Carmel High School Stadium Improvements

SCH# 2021050293

Carmel Unified School District

FINAL EIR

1 On Page: 67 you provide Figure 3-6 as the Existing On-Campus Parking Spaces and Circulation outline (Close-up Below).

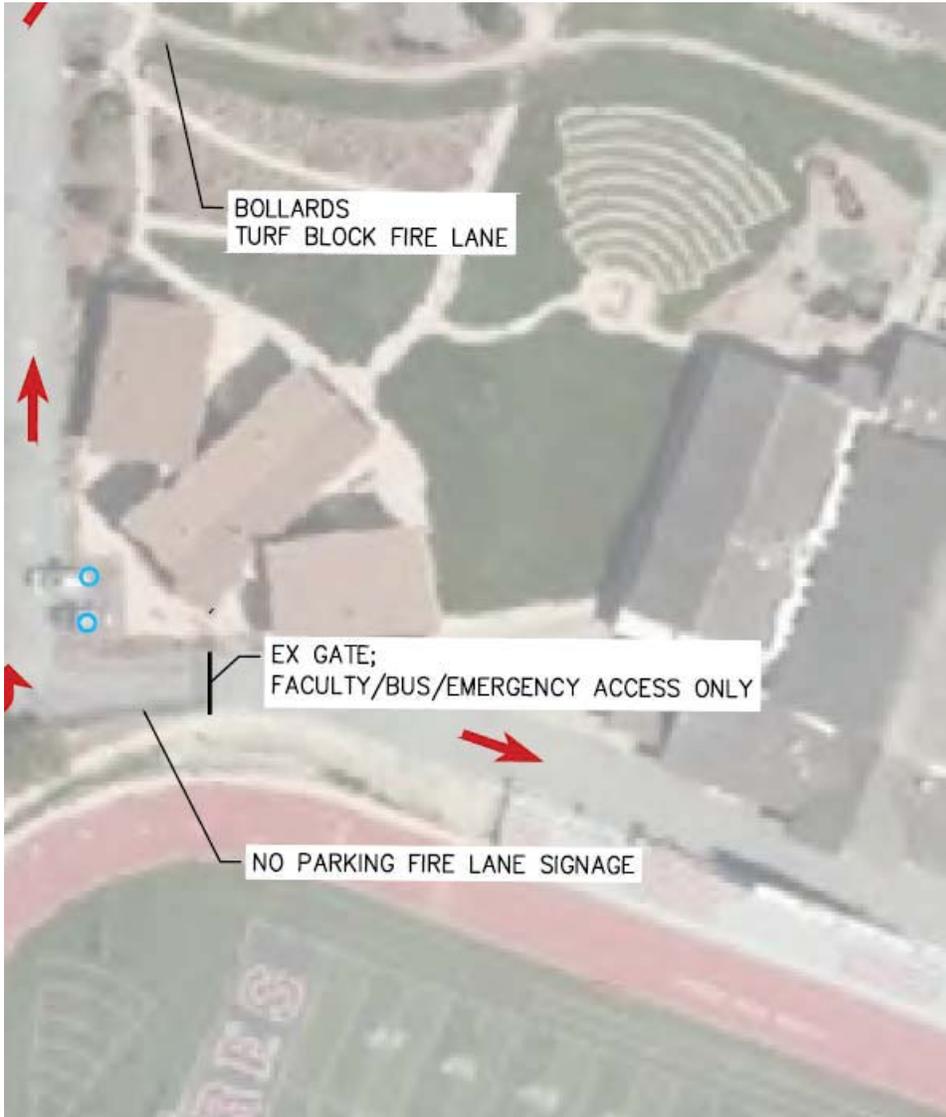
- A real photo is provided right below Figure 3-6 that correlates to where your two red arrows are shown.
- The way your two arrows are stacked on top of each other, it implies that two cars can pass each other? Is that the case? Can you provide specifics on the width of the lane?

- We don't see Firelane marked on Figure 3-6 - is that accurate to the baseball field entrance gate??
- What does "Red Curb" mean? Where does that term come from? What is the definition of the terminology? Is this an official term from another agency?

- Why does the photo we provide show a Fire Lane and your Figure 3-6 not more it accordingly?
- You are specific in Figure 3-6 that there two other fire lanes, so why aren't you including the baseball gate entrance as part of the accurate fire lane marking?

- You identify what is the parking but what do the red-lines mean?
- What is that red-line in-front of the Tennis Court Mean?
- How do these red overlap with page 73 where you have Figure 4-1?

1. This comment is regarding Figure 3-6, Existing On-Campus Parking Spaces and Circulation, which is on page 3-23 of the RDEIR (page 67 of the PDF). This figure presents *existing* on-campus parking spaces and circulation. The red arrows indicate existing ingress and egress from Morse Drive to the baseball field. As indicated on Figure 3-6, the red lines show the location of existing red curbs. No changes to these existing red curbs are proposed. The photo provided in this comment is a photograph of this existing road. No changes to this internal road are proposed or necessary. Photos of the existing pedestrian pathways can be found at Figure 3-4 of the RDEIR. A description of the proposed pedestrian path improvements is found starting on pages 3-16 and 4-21. Figure 4-10 shows the proposed locations of the pedestrian path, and Figure 4-9 shows closer detail of the proposed pedestrian path located along the existing red curb. Black arrows on Figure 4-10 indicate paths of vehicle travel at the new 20-foot driveway, along the new 18-foot drive aisle, and within the proposed new tennis court parking lot.

To highlight both the existing and proposed red curbing on and around the proposed tennis court parking lot in order to provide adequate access for emergency access vehicles, a revision has been made to Figure 4-10 showing all red curbing. See Section 3.0, Changes to the Revised Draft EIR, of this final EIR for this revised figure.

Fig. 2. Map (5.2) from CUSD’s RDEIR showing areas in Red (land) or Purple (ocean) that may “see” the CHS lights within a 3.5-mile radius of campus. Note the newly predicted impacts West of CHS (black dot).

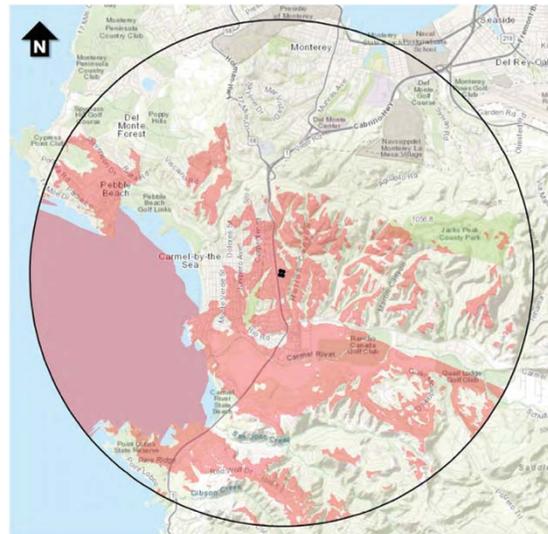
In response to these criticisms, the District’s new RDEIR contains a similar and more complex spatial analysis showing locations in the region that “may see” the CHS Stadium Lights by virtue of their line-of-sight with the campus (black dots) (Fig. 2 here, and Fig. 5-2 in RDEIR).

The commenter refers to PDF page 127, which is Figure 5-2, Viewshed Analysis Map, of the RDEIR. It is unlikely that the lights could be viewed from Carmel River State Beach due to the low elevation and intervening topography. The lighting may be seen from portions of Point Lobos State Reserve. Refer to page 5-39 of the RDEIR under the impact 5-1 discussion of “Effects of Scenic Vistas and the Visual Character and Quality of the Project Site.”

Page 7-3, Figure 7-1, Habitat Map

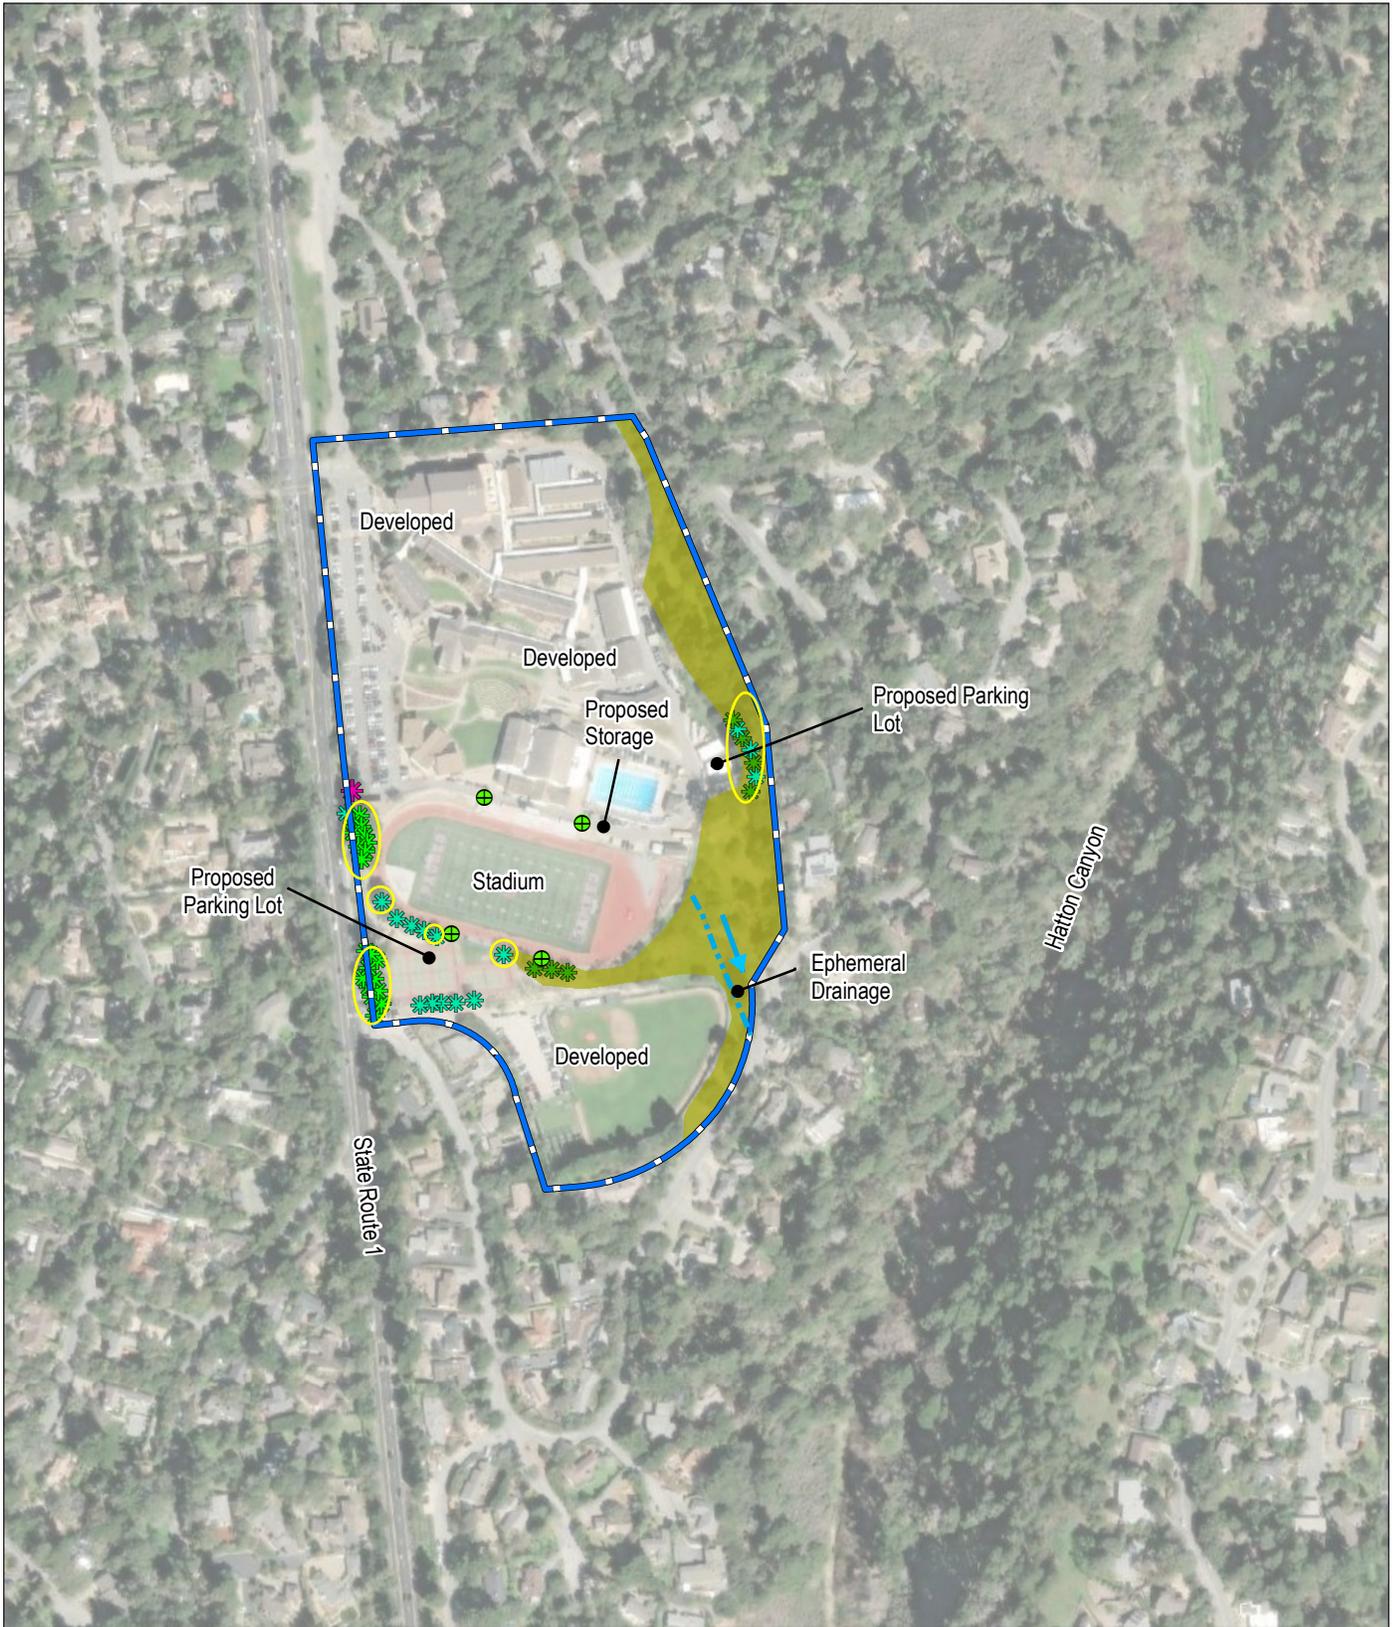
PAGE 201: You state Below. Can you provide a visual map and markings of the referenced locations? Is only one drainage referenced on Figure 7-1?

Regarding the drainage addressed in the RDEIR, its location is identified on Figure 7-1, Habitat Map, with a blue dotted line and the notation "Ephemeral Drainage." Regarding drainages within a three-mile radius, it is not necessary to identify these, as there is no potential for the proposed project to affect them. Regarding Hatton Canyon and the red-legged frog, see response to Letter 2b, comment 4.
